TO: Mayor Keisha Lance Bottoms
ATTN TO: Monique Forte, Planner III
FROM: Douglas R. Hooker, Executive Director
RE: Development of Regional Impact (DRI) Review Finding

Name of Proposal: Project Revive DRI 3489

DRI Number # 3489
DRI Title Project Revive: CSX Tilford Yard Industrial Development
County Fulton County
City (if applicable) Atlanta
Address / Location West side of Marietta Road NW on the former CSX Tilford railyard site.

PROJECT REVIVE: CSX TILFORD YARD DRI
City of Atlanta
Natural Resources Group Review Comments
November 30, 2021

GSWCC CERT. (LEVEL II)	
DRAWN BY	HED
DESIGNED BY	BWS
REVIEWED BY	BWS
DATE	11/23/2021
PROJECT NO.	
TITLE	
OVERALL DRI SITE PLAN	
SHEET NUMBER	
C2-00

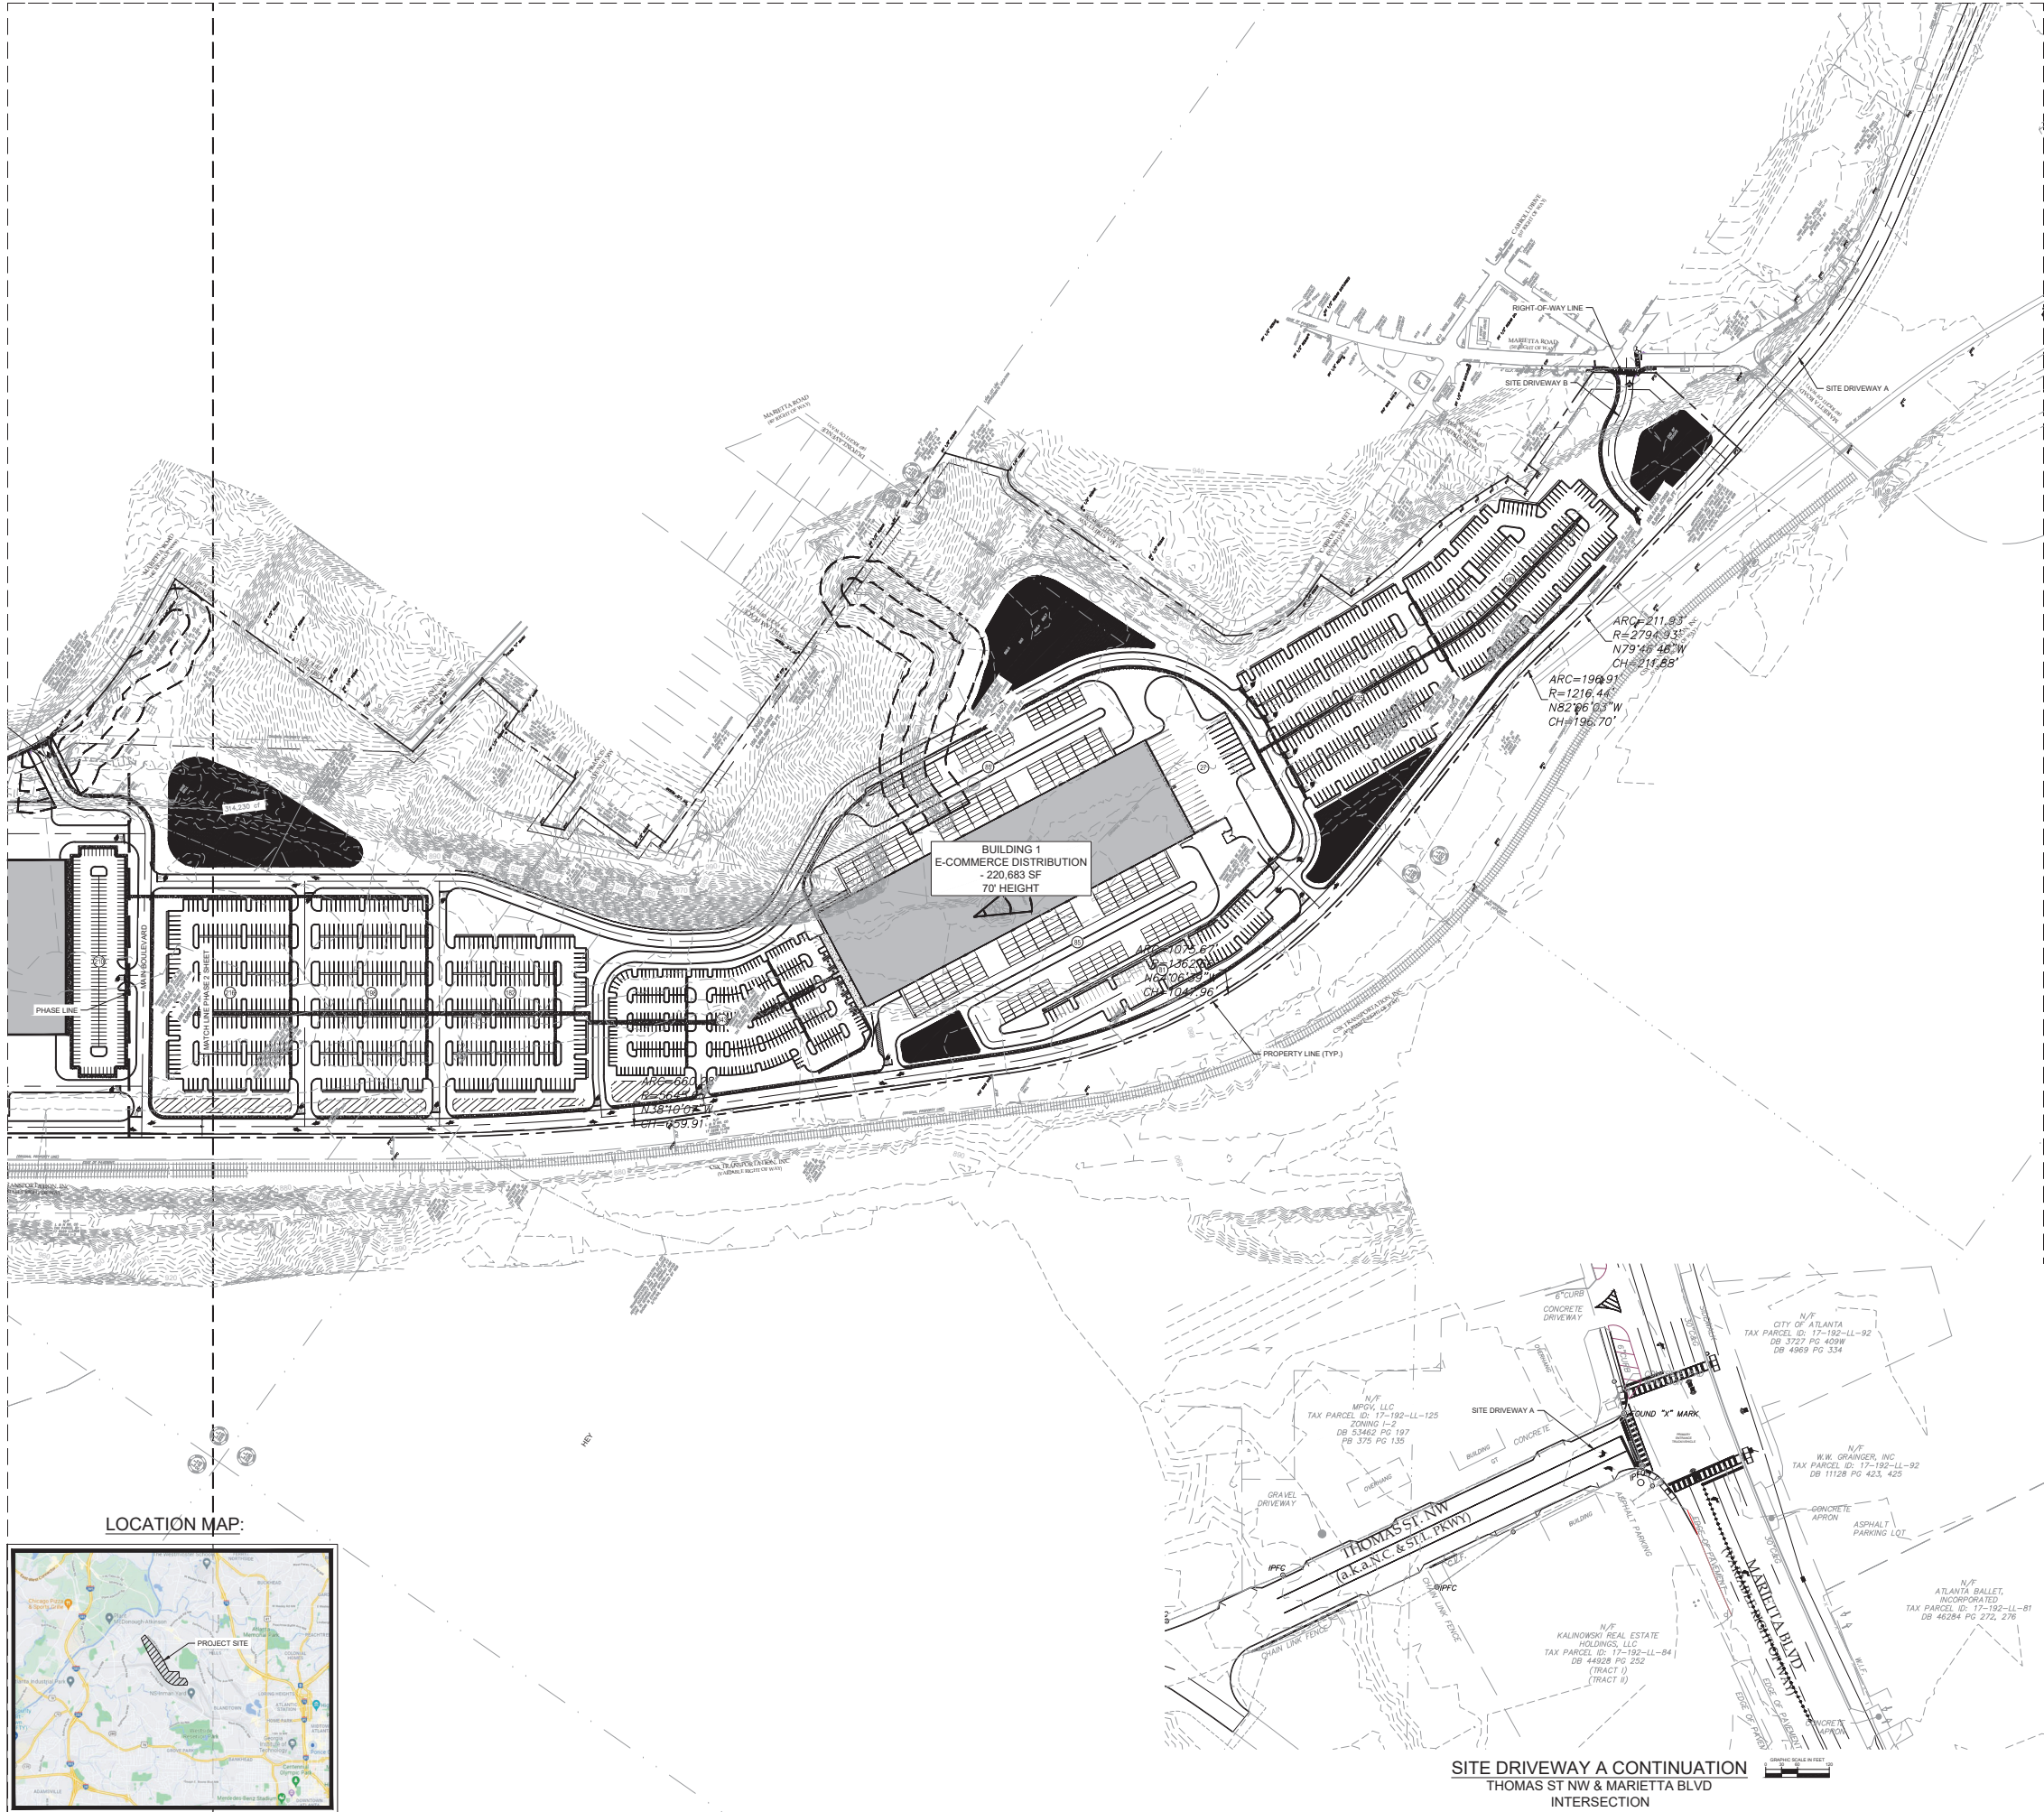
The site plan also shows two other short unmapped streams on the property. The first parallels Marietta Road roughly between Ford Street and Westside Boulevard. The second stream starts between William Place and DuPont Avenue and runs south into the property and appears to be piped under the existing development. However, proposed construction, including an access road is shown over the first of these streams and apparent parking or storage areas are shown within the buffer areas of both streams. Generally, development should avoid intrusion into stream buffers unless there are exceptional circumstances. Any intrusions may require variances under the both the City Stream Buffer Ordinance and the State 25-foot State Erosion and Sedimentation Control buffer. Any other unmapped streams on the property may also be subject to the City and State buffer areas.

The project proposes to construct approximately 1,739 parking spaces mostly in the form of surface parking. This is a very large increase in impervious area from the existing semi-pervious gravel areas used for railroad operations. This introduction of these very large areas of asphalt surface will generate substantial new runoff and contribute to the urban heat island effect experienced by the City of Atlanta. These extensive new surface parking lots should be designed to include green infrastructure to the maximum extent possible to limit runoff and achieve groundwater recharge. Further, the tree planting plan for the parking lot should ensure the greatest canopy coverage possible to mitigate the heat island impact of the very large asphalt area being added. The project can further support The Atlanta Region's Plan in general by incorporating other aspects of regional policy, including green infrastructure and/or low-impact design, e.g., pervious pavers, rain gardens, vegetated swales, etc., in parking areas and site driveways, and as part of any improvements to site frontages.

- Answer states NOT APPLICABLE but trucks are definitely applicable - the site plan shows one hundred eight seven (187) 55’ long parking stalls in the industrial warehouse section to the northwest, and twenty seven (27) 55’ long parking stalls in the e-commerce section (in addition to one hundred

seventy (170) 28'-40' loading areas for single unit trucks or large delivery vans). Developer needs to adjust the site plan so that it is clear that trucks are only allowed to use Driveway 3 – Thomas St Ext. Internal signage and pavement markings may be helpful.

- Provide additional details around the proposed conditions where the existing Thomas Street meets Marietta Road, the northern terminus of the Marietta Road Bridge over Tilford. The site plan does not provide any details around whether this connection will continue to exist or not.
